C-200, OFFSITE DOSE CALCULATION MANUAL REVISION 43
(231 PAGES)

FPL	<h1 style="margin: 0;">ST. LUCIE PLANT</h1> <p style="margin: 0;">CHEMISTRY OPERATING PROCEDURE</p> <p style="margin: 0;">SAFETY RELATED REFERENCE USE</p>	Procedure No. <h2 style="margin: 0;">C-200</h2>
		Current Revision No. <h2 style="margin: 0;">43</h2>

Title: **OFFSITE DOSE CALCULATION MANUAL (ODCM)**

Revision 43 - Incorporated PCR 1971488 to incorporate changes documented in EC 277010 for replacement of U1 FHB Rad Monitor. Updated monitor channel IDs. The new U1 FHB Rad Monitor does not have an iodine channel. (Author: J. Hunt)
 AND
 Incorporated PCR 1970406 to provide improved guidance during gaseous radiation monitor inoperability and when annunciation is lost to the control room. Removed unclear guidance that releases may continue during inoperability for up to 30 days. (Author: J. Hunt)
 AND
 Incorporated PCR 1994917 to remove the goat from Figure 1-2 located at "WSW-3.5, GOAT". The goat is no longer at this location as documented in the Annual Land Use Census. (Author: J. Hunt)
 AND
 Incorporated PCR 2002584 to improve guidance for conducting REMP Program Supplemental Sampling. (Author: J. Hunt)

FIGURE 1-2
ENVIRONMENTAL SAMPLE LOCATIONS (10 MILES)
(Page 1 of 1)

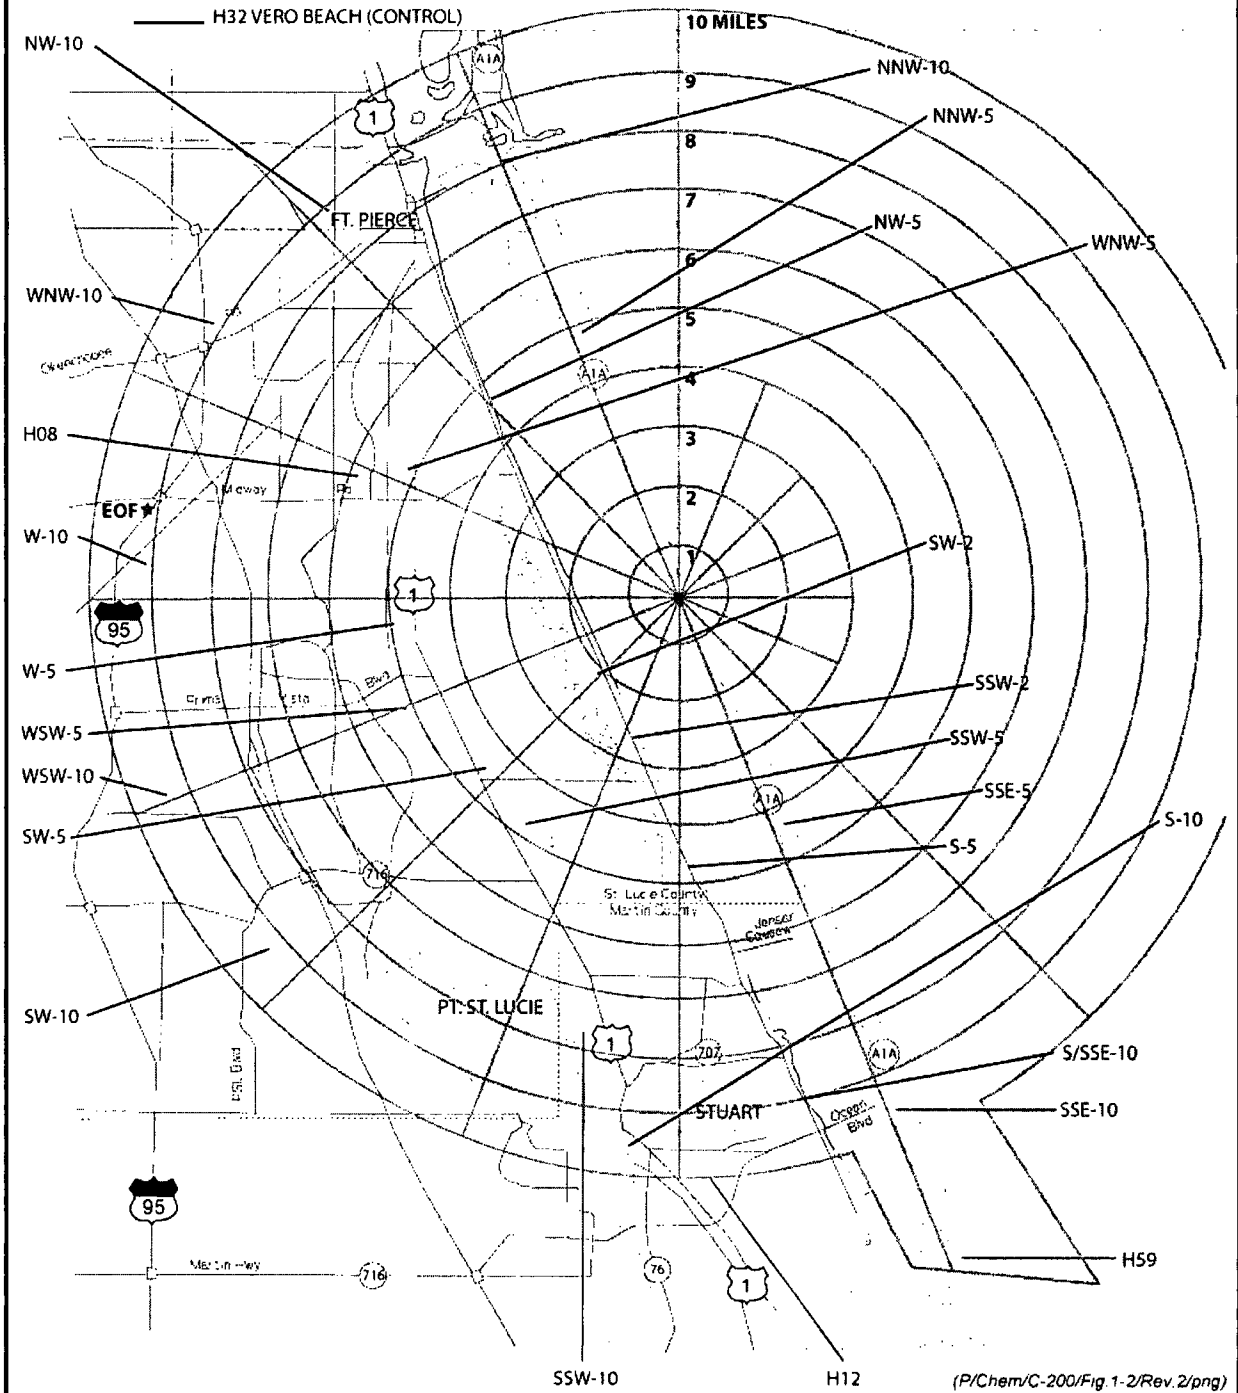
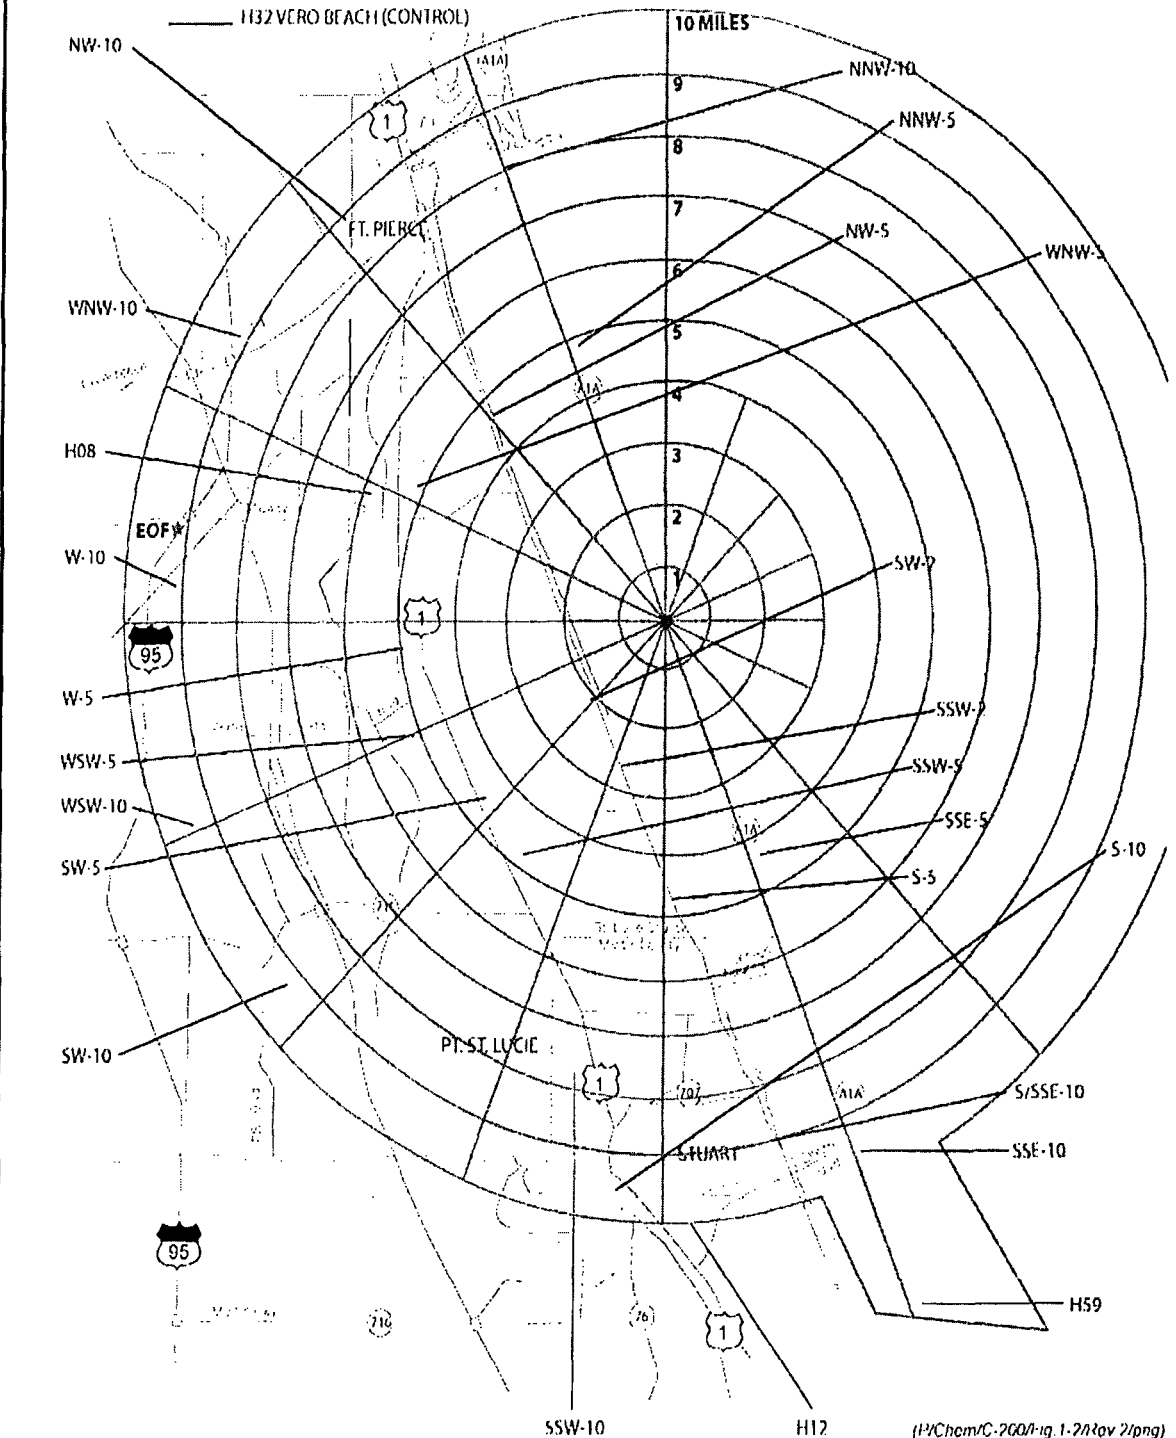
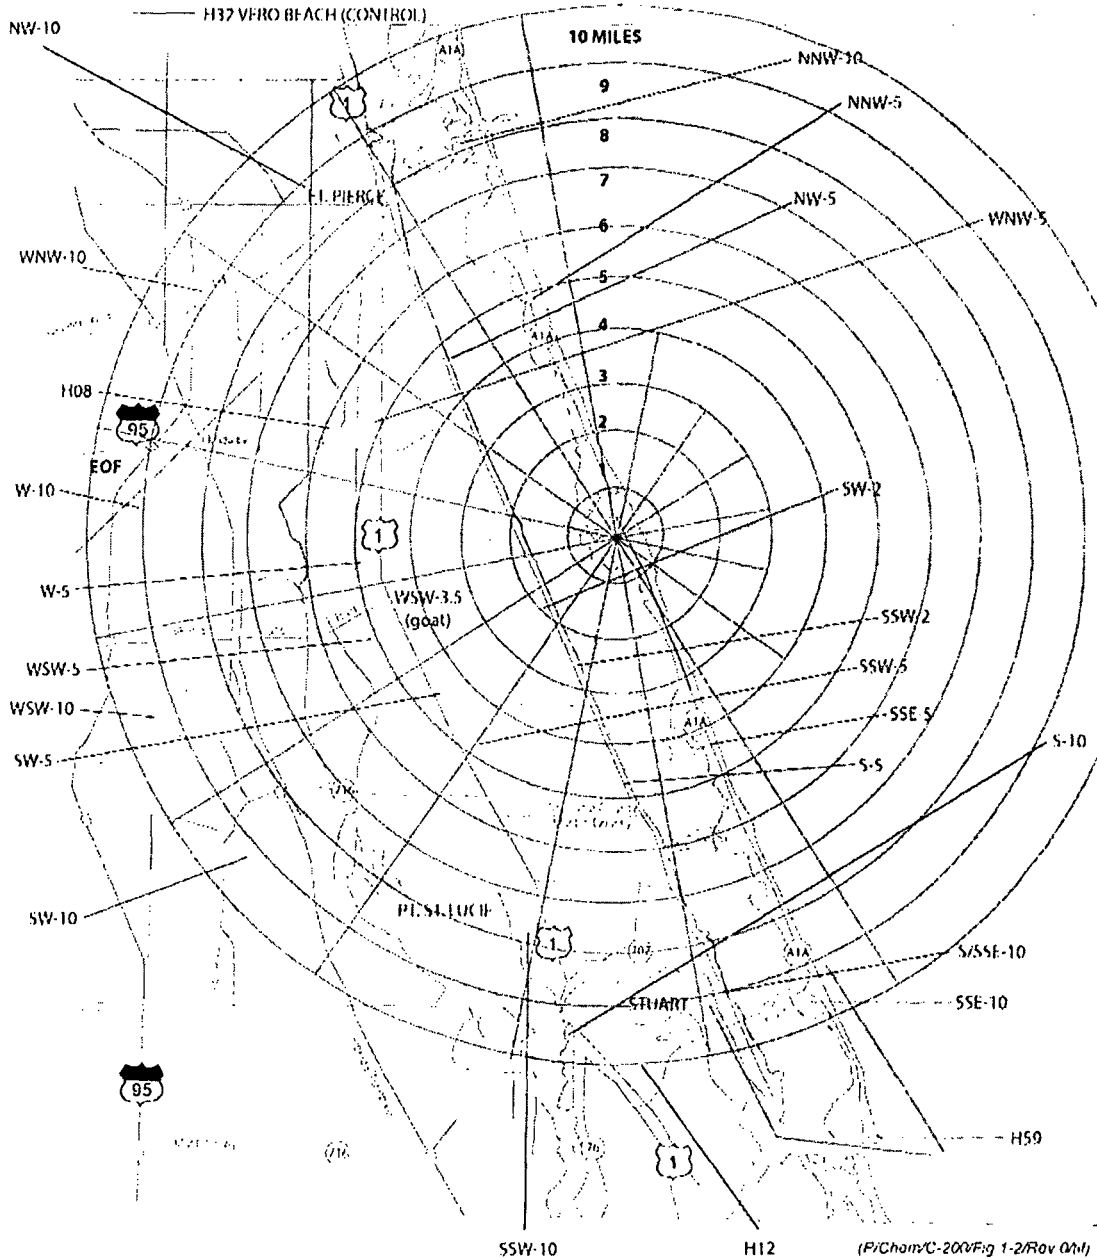
Revision 43 - Incorporated PCR 1994917 to remove the goat from Figure 1-2 located at "WSW-3.5, Goat". The goat is no longer at this location as documented in the Annual Land Use Census. (Author: J. Hunt)
